**HAM CR 251 0.11
 BLUE ASH RD PH 2**

CITY OF DEER PARK
 HAMILTON COUNTY

REVIEW COMPLETE

STAGE 1 SUBMITTAL - 2/14/2025

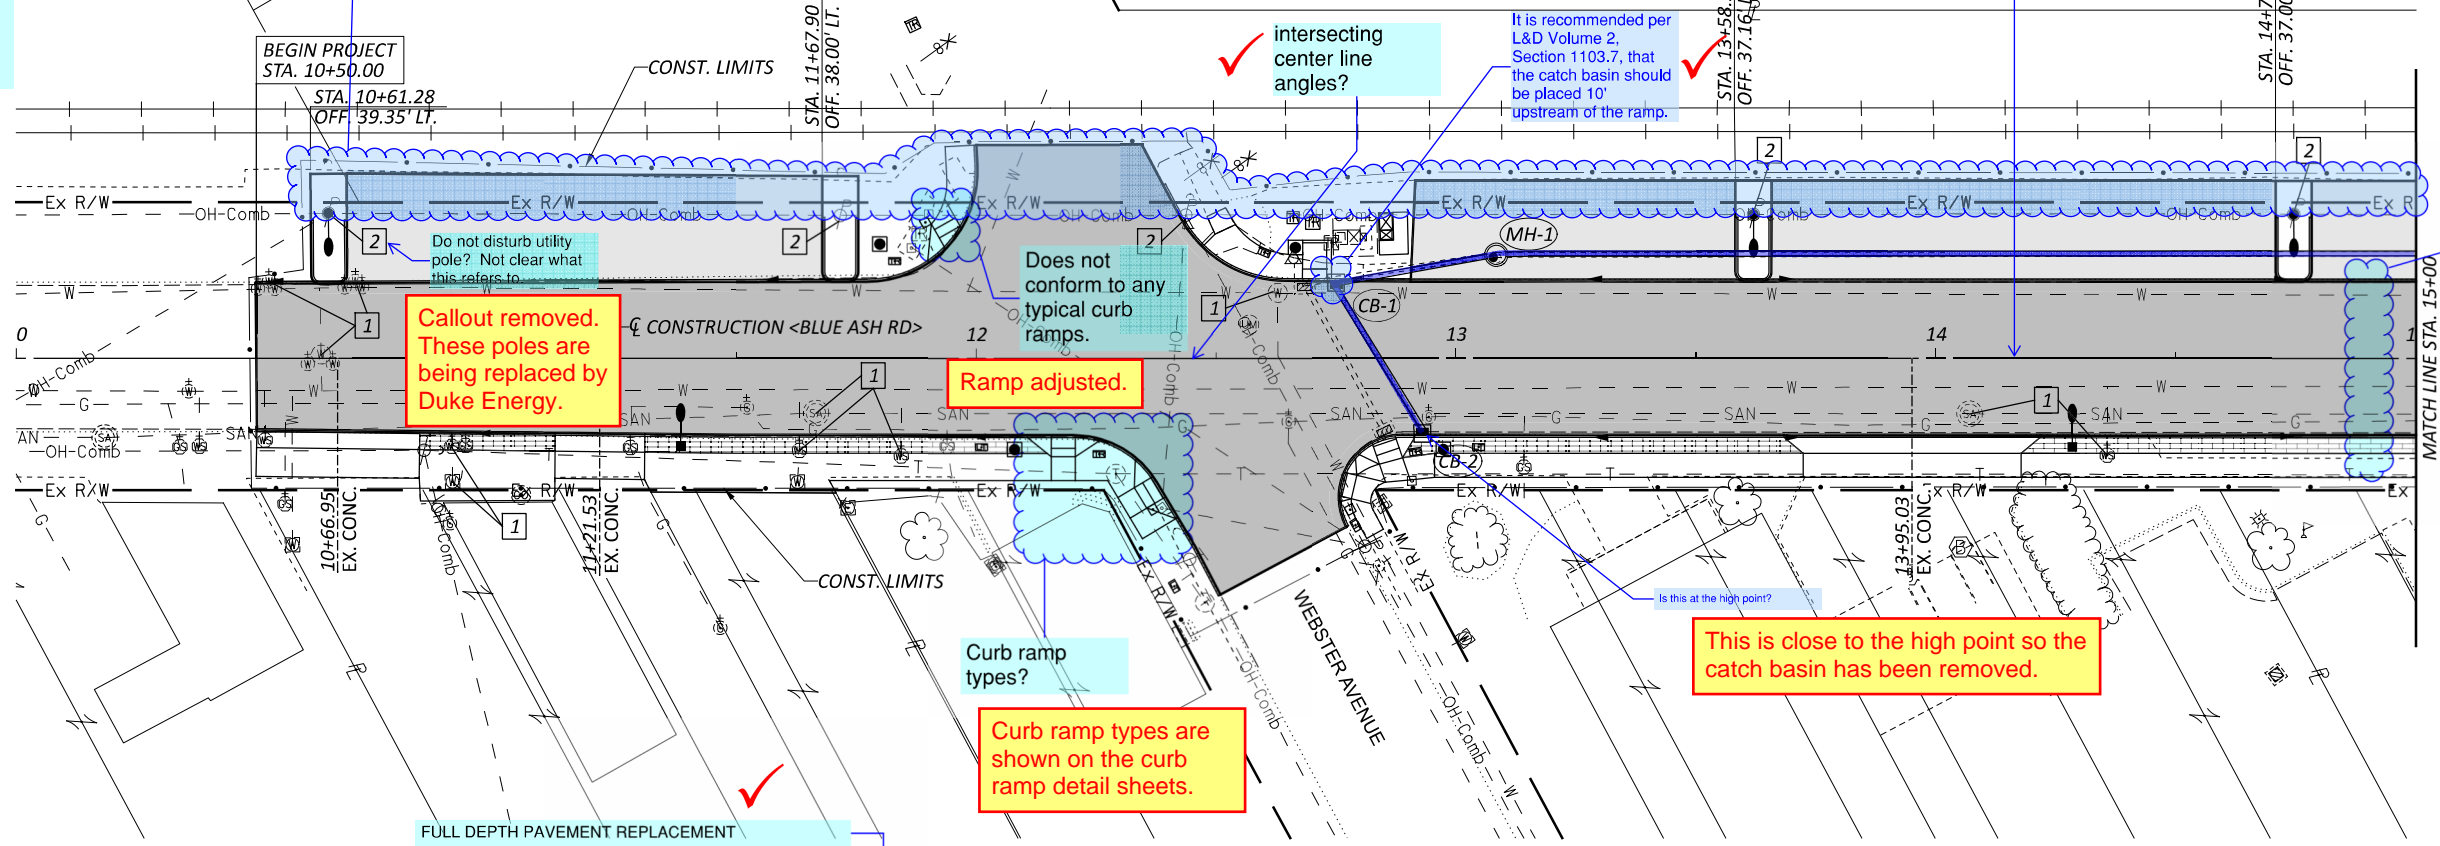
The only work in advance of the BEGIN PROJECT flag is 2 advance signs for the MOT work.

BEGIN WORK LIMITS: STA. 7+50.00...provide a brak line or shown on separate plan sheet depending on what is included in the work limits.

Typical comment, construction limits outside of RW

The city has an agreement with the railroad to resurface this area within the RR RW.

PLAN AND PROFILE
STA. 10+50 TO STA. 15+00

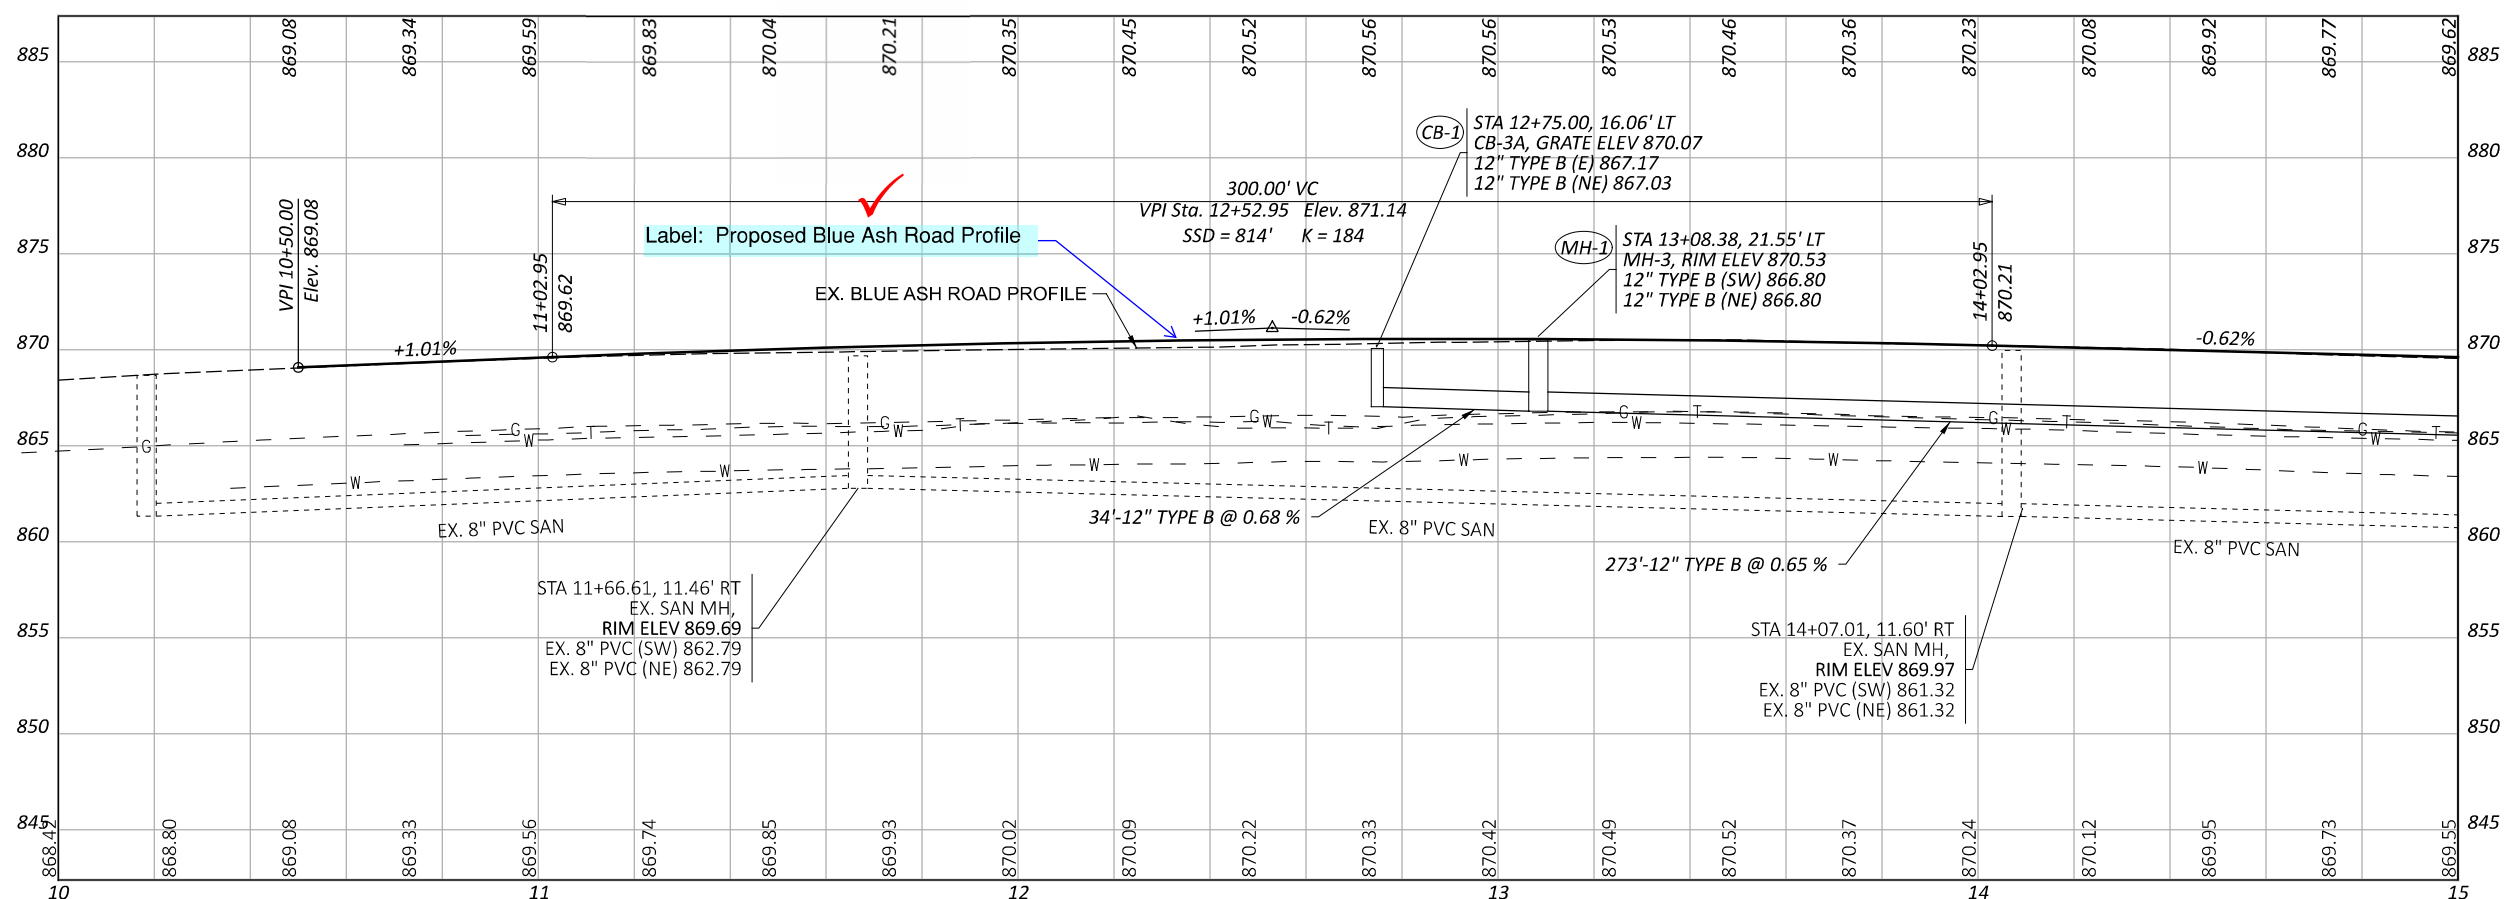
Show center line bearings on each P&P sheet.

Show pavement width information on each P&P sheet.

Callout removed. These poles are being replaced by Duke Energy.

Ramp adjusted.

Curb ramp types are shown on the curb ramp detail sheets.

PLAN AND PROFILE
STA. 15+00 TO STA. 20+00

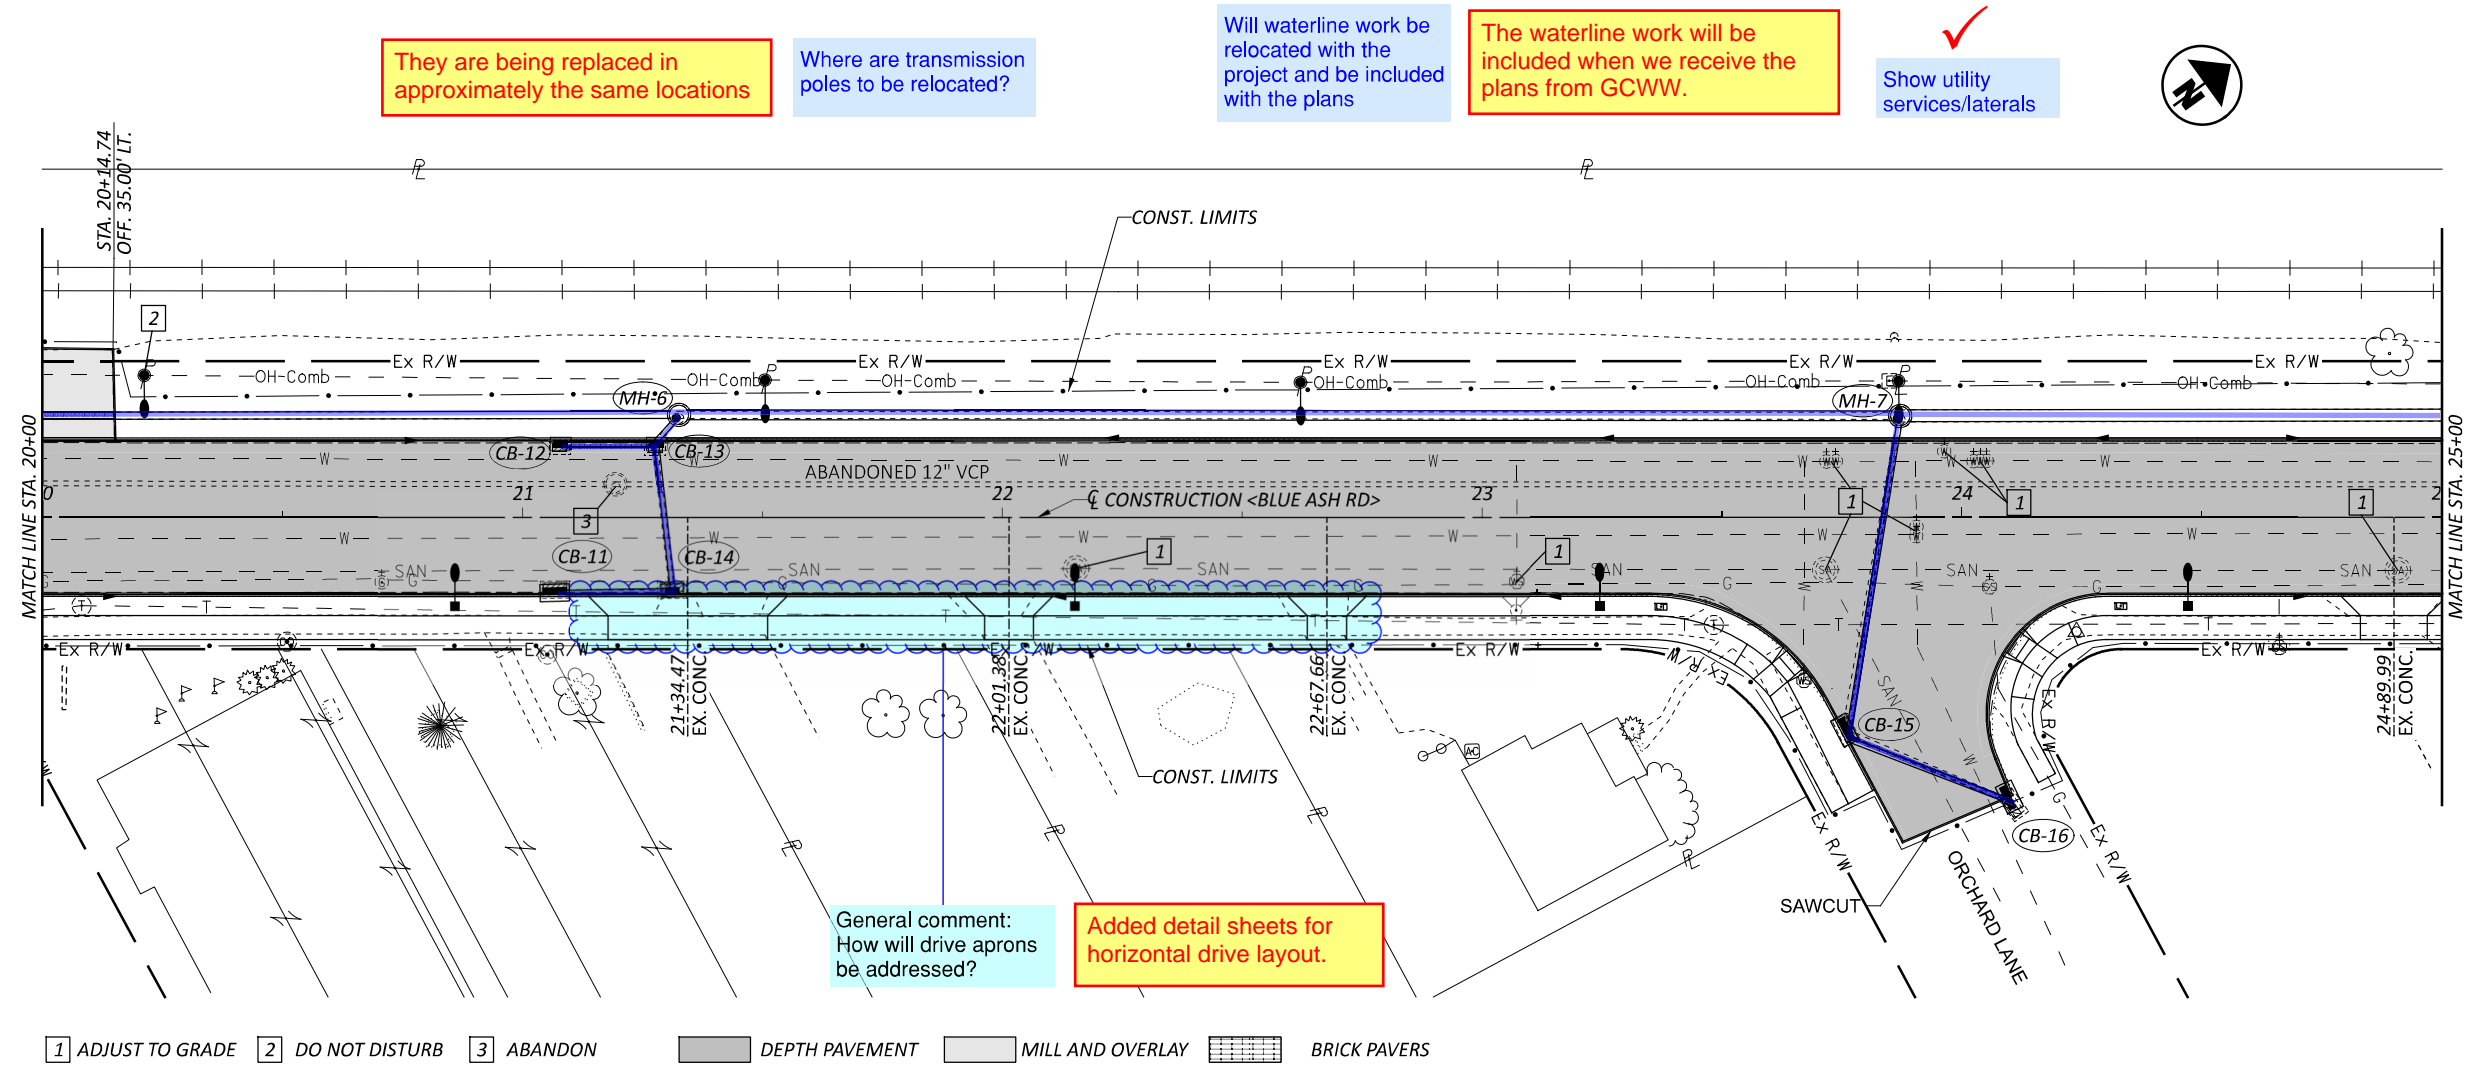
Where are transmission poles to be relocated?

Will waterline work be relocated with the project and be included with the plans

They are being replaced in approximately the same locations

The waterline work will be included when we receive the plans from GCWW.

PLAN AND PROFILE
 STA. 20+00 TO STA. 25+00

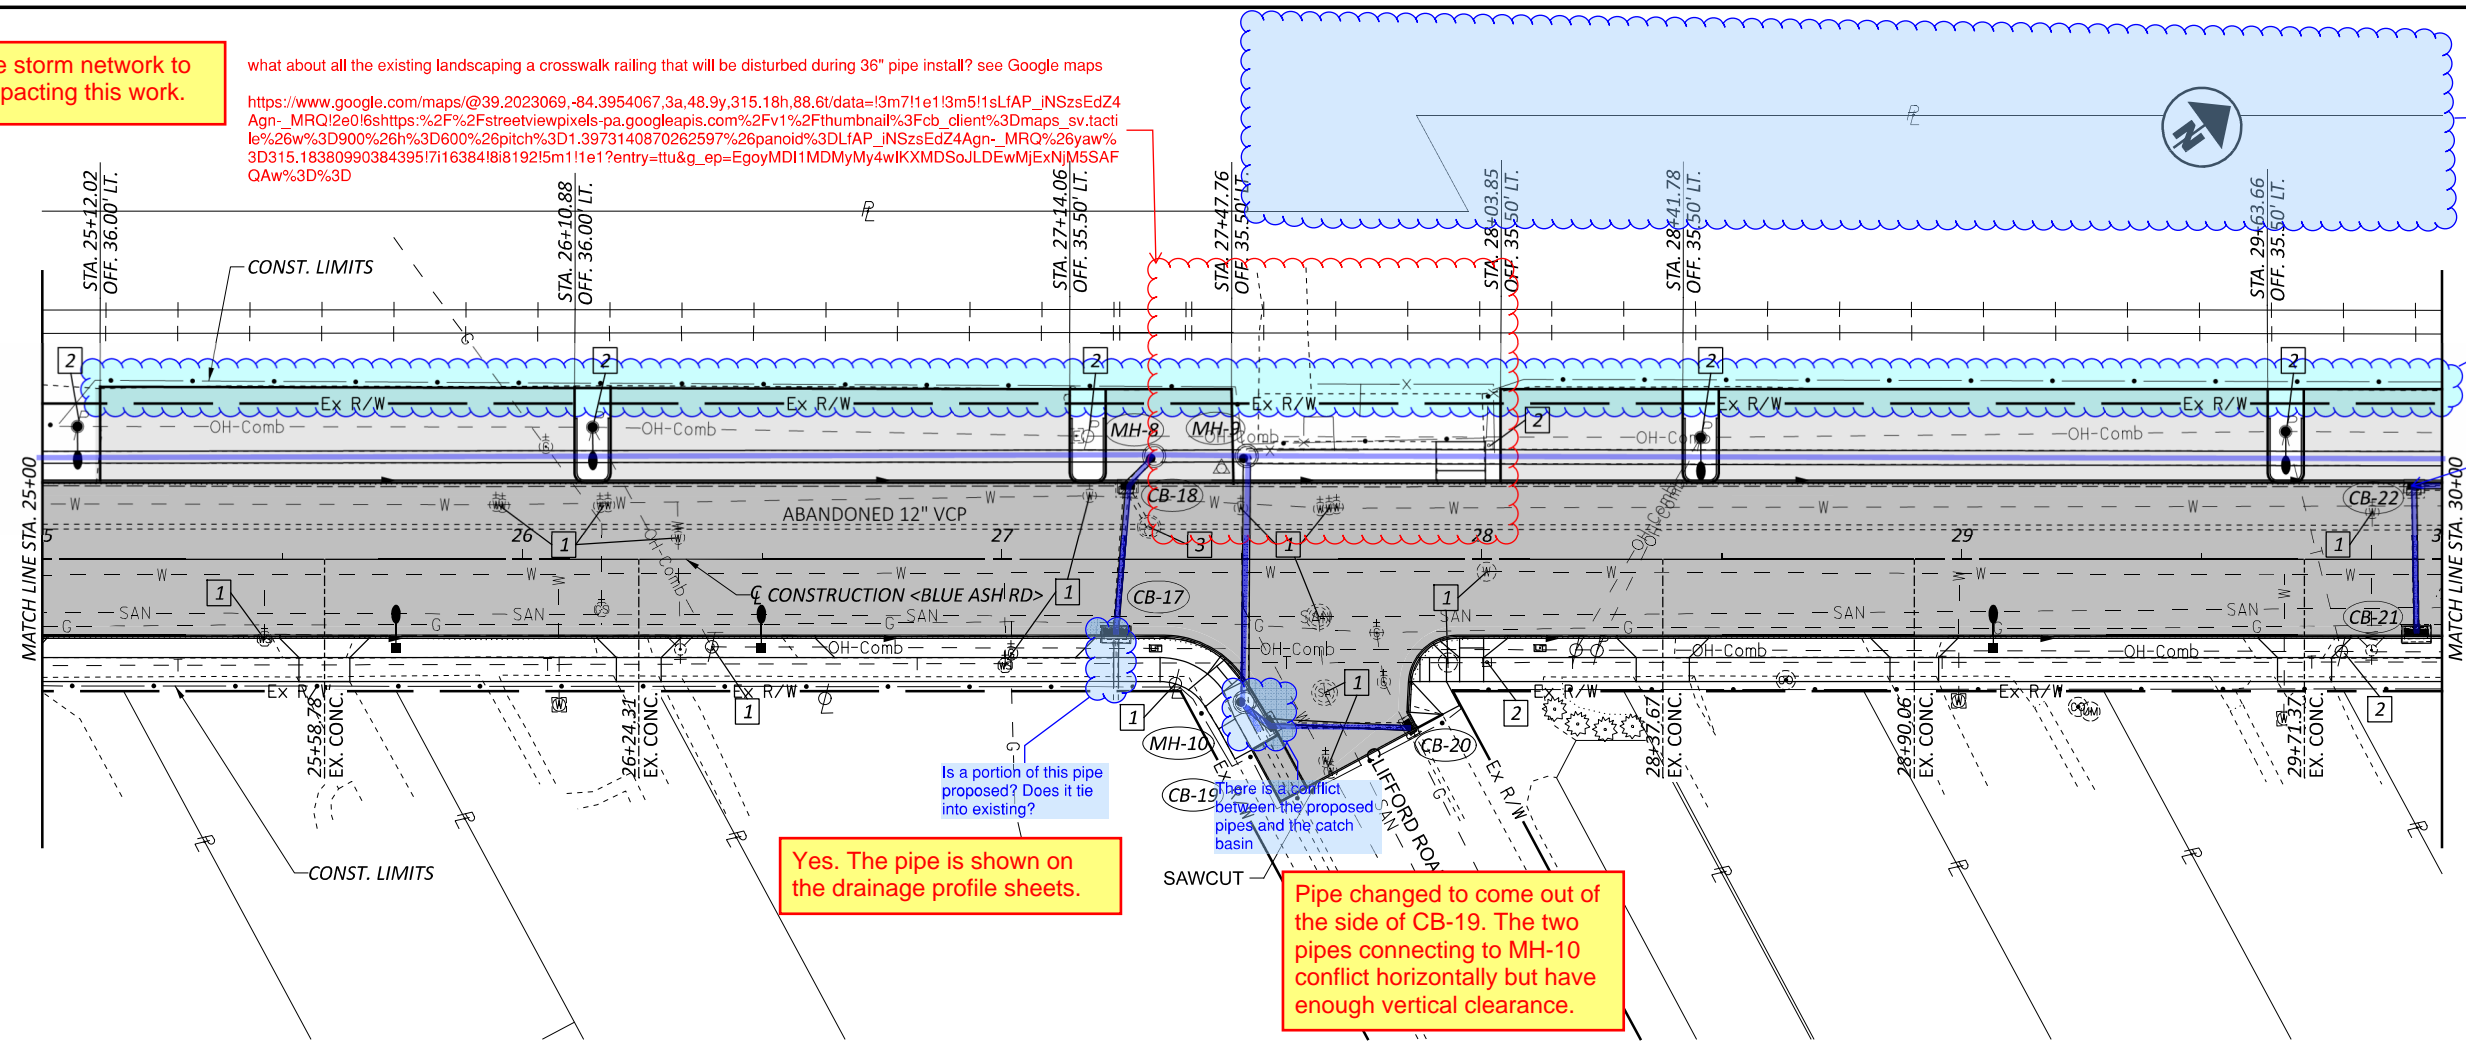
what about all the existing landscaping a crosswalk railing that will be disturbed during 36" pipe install? see Google maps

Identify as Chamberlin Park

Adjusted the storm network to minimize impacting this work.
